US-APWR DCD Tier 1 Enhancement Project

Thursday 2/17/11 Handout 1

US-APWR DCD Tier 1 Enhancement Effort

**APWR DCD Tier 1 Improvement Effort
Bases for “Generic” ITAAC Changes**

Figure 1: Example Design Description Markup

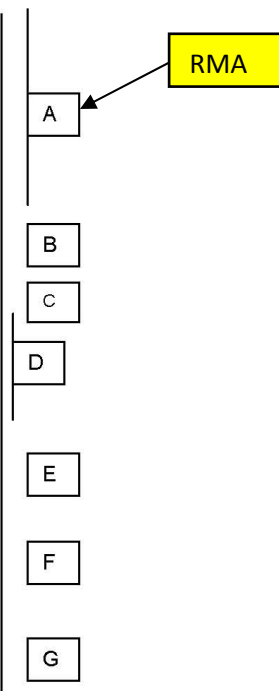
~~The necessary information important to safety is available for the display at the following facilities:~~

- ~~• Main control room (MCR)~~
- ~~• Remote shutdown room (RSR)~~
- ~~• Technical support center (TSC)~~
- ~~• Emergency operations facility (EOF)~~

~~Controls for credited manual operator actions are available in the MCR.~~

~~Figure 2.5.4-1 shows the configuration of the PSMS and PCMS for implementation of the information systems important to safety. The PSMS redundancy, independence, testability, qualification, quality and life cycle descriptions of Subsection 2.5.1 are also applicable to the information systems important to safety within the PSMS. The PCMS redundancy, qualification and quality descriptions applicable to the information systems important to safety are as described in Subsection 2.5.5.~~

1. PAM variables as identified in Table 2.5.4-1, BISI, SPDS information, and plant alarms for credited manual actions as identified in Table 2.5.4-3, for information systems important to safety, are provided on safety and non-safety HSI equipment at the MCR, RSR, TSC, and EOF, as shown in Figure 2.5.4-1.

2. Deleted.

Item No.	Explanation/Basis for Change
Design Description Section 2.5.4.1	
A	Notes 1 and 2. See Item F.
B	Information deleted; redundant to Figure 2.5.4-1 note, and controls for credited manual operator actions are the subject of other Tier 1 sections, Section 2.5.4 is about information systems.
C	Notes 1 and 2 (first sentence of paragraph). See Item F.
D	Text revised (second and third sentences deleted) to include only the necessary attributes for Tier 1 Design Description introductory information.
E	Added reference to new table.
F	Notes 1 and 2. See Items A and C.
G	Note 1.
H	Note 1.
I	Note 1.
